June 29, 2001

JB 18457-I

Addendum Geologic and Soils Engineering Exploration Report #2
Proposed Landslide Repair and Multi-Unit Condominium and Town Home Buildings
Tentative Tract 52928
17331-17333 Tramonto Drive
Pacific Palisades, California

Grading Section Log # 31587-01

SECTION I

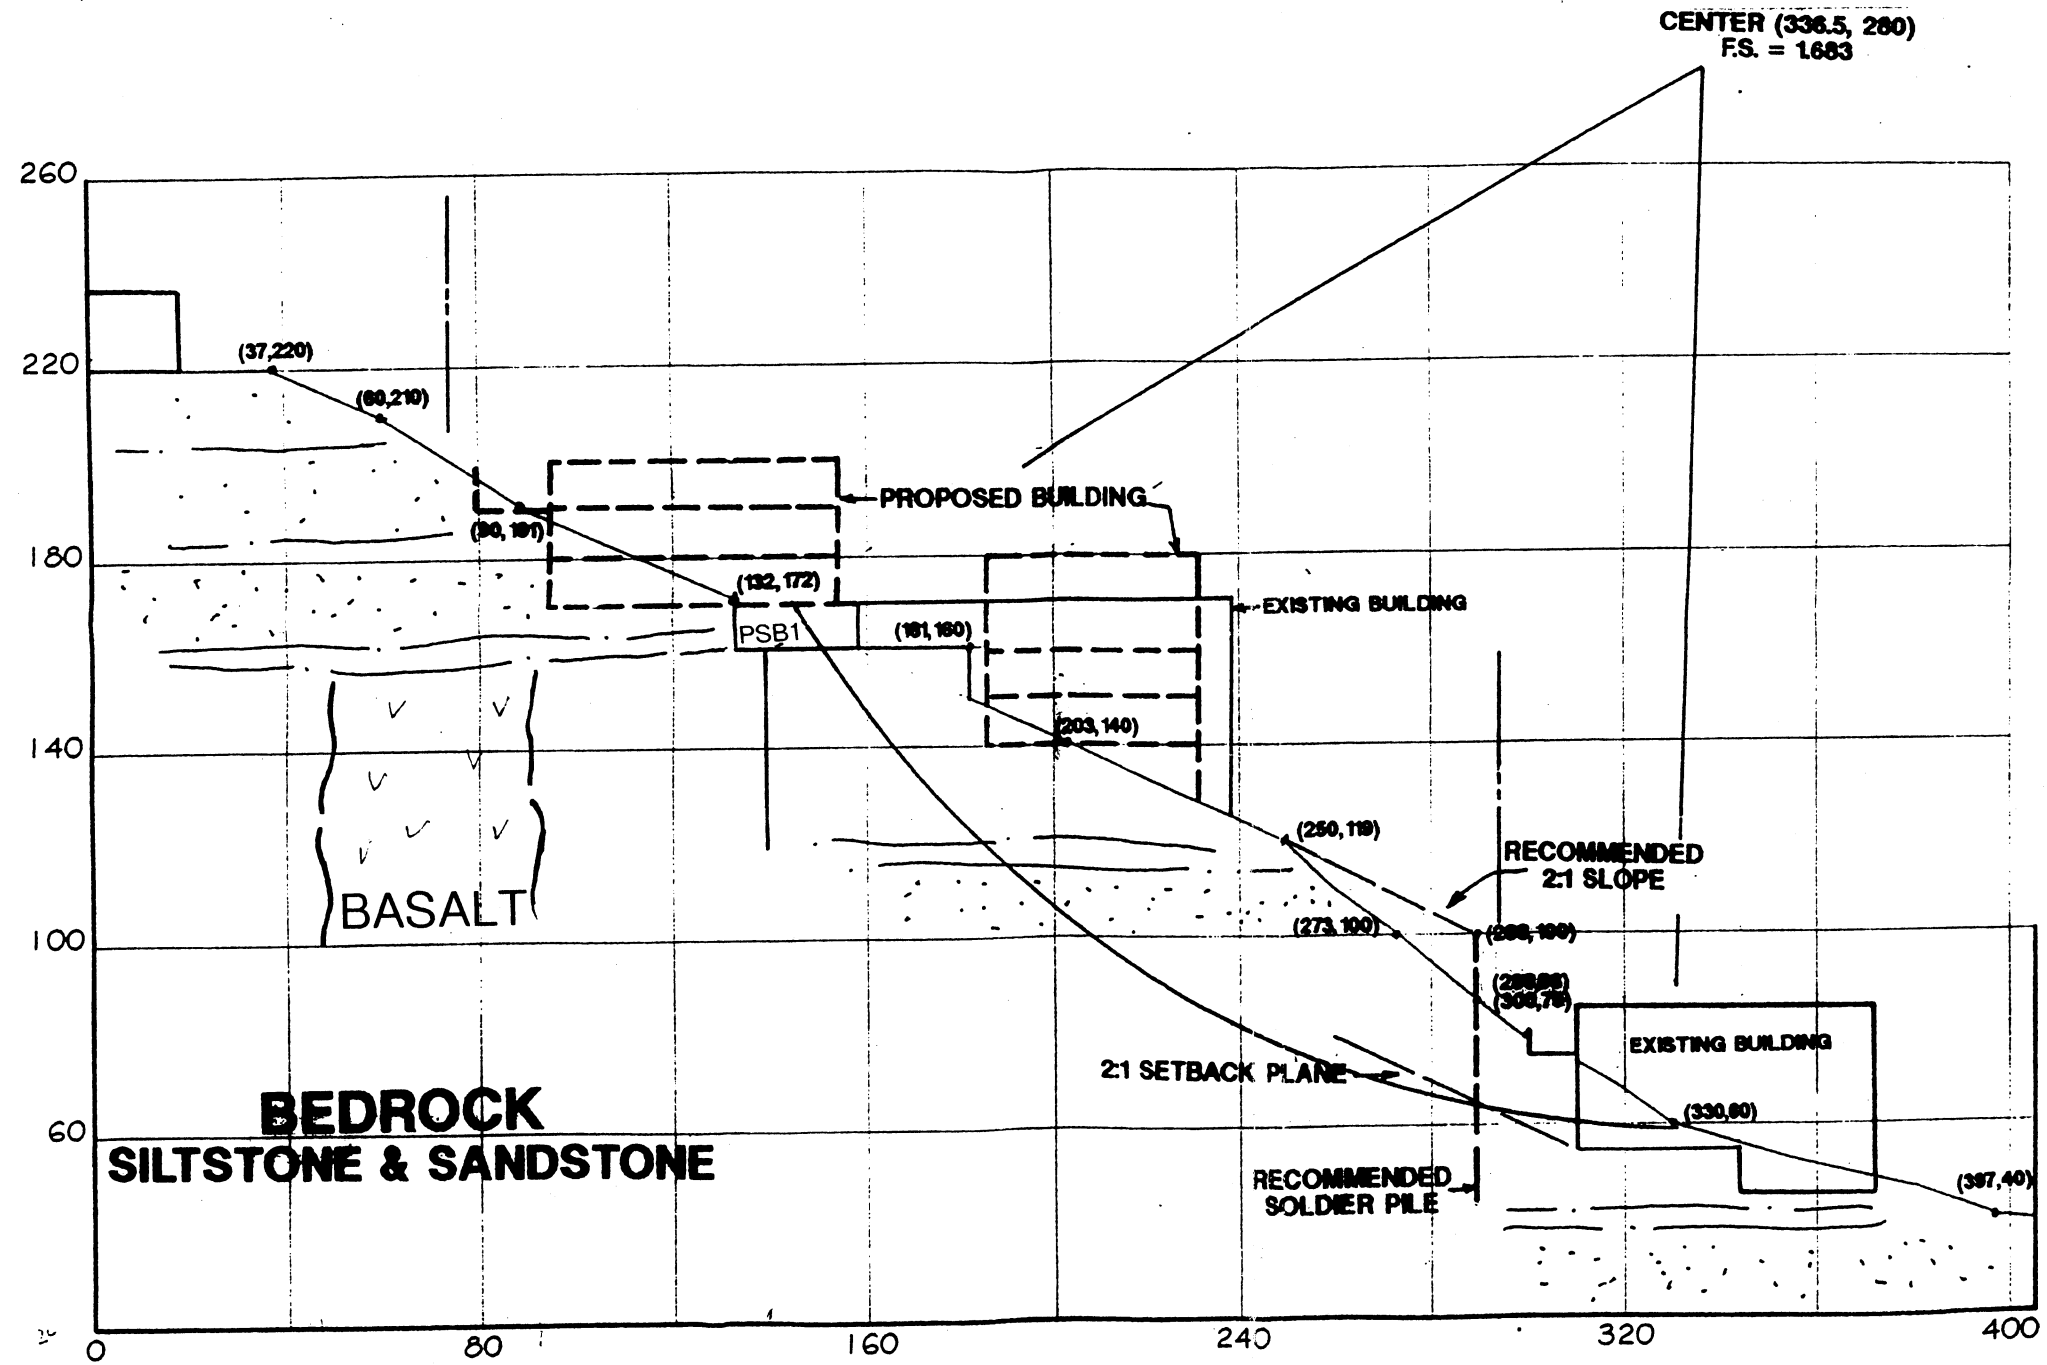
Item 11 - *Cross-section I shows existing building, but no building is shown on Geologic Map, please clarify. The basalt is not shown on the cross-section. In addition, show the location of boring PS1B. Determine the minimum depth of soldier pile below the plane with 1.5 factor of safety.*

The proposed development plans of the site provided by the architect do not include the existing structures. The existing structures are shown on the Santa Monica Mountains topographic maps. The basalt, as well as PS1B are shown in revised Section I. Soldier piles should be embedded at least 20 feet below the 1.5 factor of safety plane.

SECTION H-H

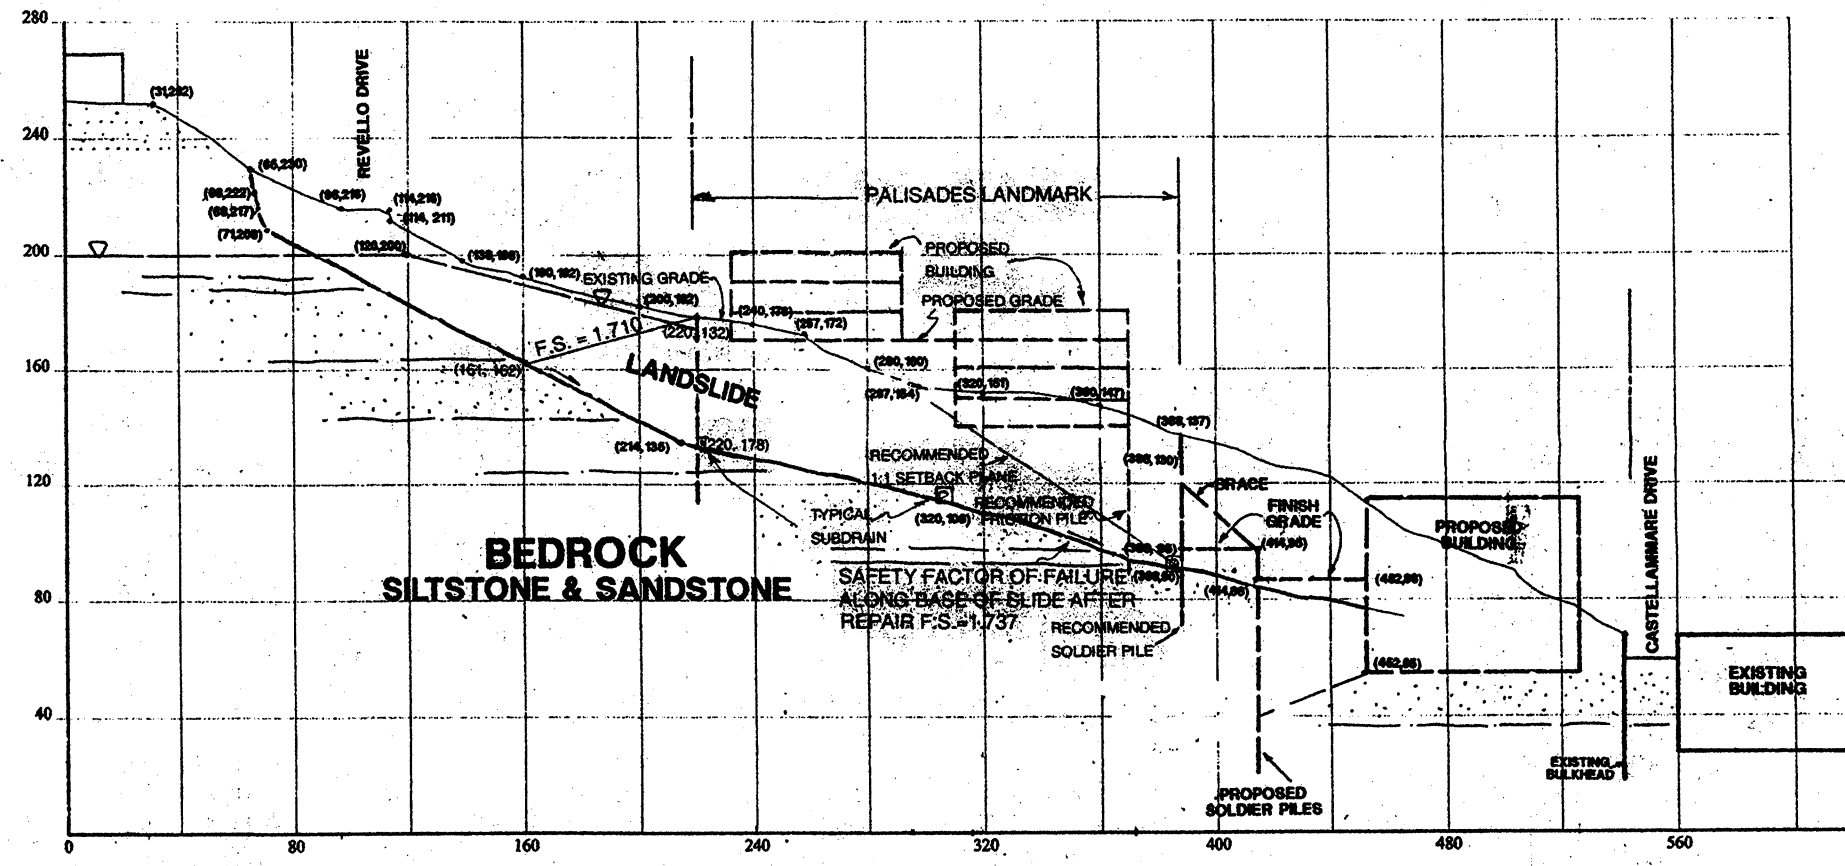
Item 10 - *Provide design recommendations for the lower row soldier pile system subject to surcharge from the proposed structure shown on cross-section H.*

Item 16 - *Provide analyses for overtopping of the landslide over the proposed retaining wall.*

As recommended in the preliminary report, piles are recommended to support the southern portion of Building 2 below a 1:1 setback plane projected up from the base of the lower soldier piles. Piles should be a minimum of 24 inches in diameter and a minimum of eight feet into fill below the setback plane. Therefore, the lower soldier pile row will not be surcharged by the proposed structures. Section H shows the setback plane and deepened foundations.

An over-topping failure was modeled based upon Section H, which is the most critical with respect to stability. Calculations sheets 7 and 8 indicate the safety factor for an over-topping failure will be greater than 1.5. The hypothetical failure surface is shown on Section H.
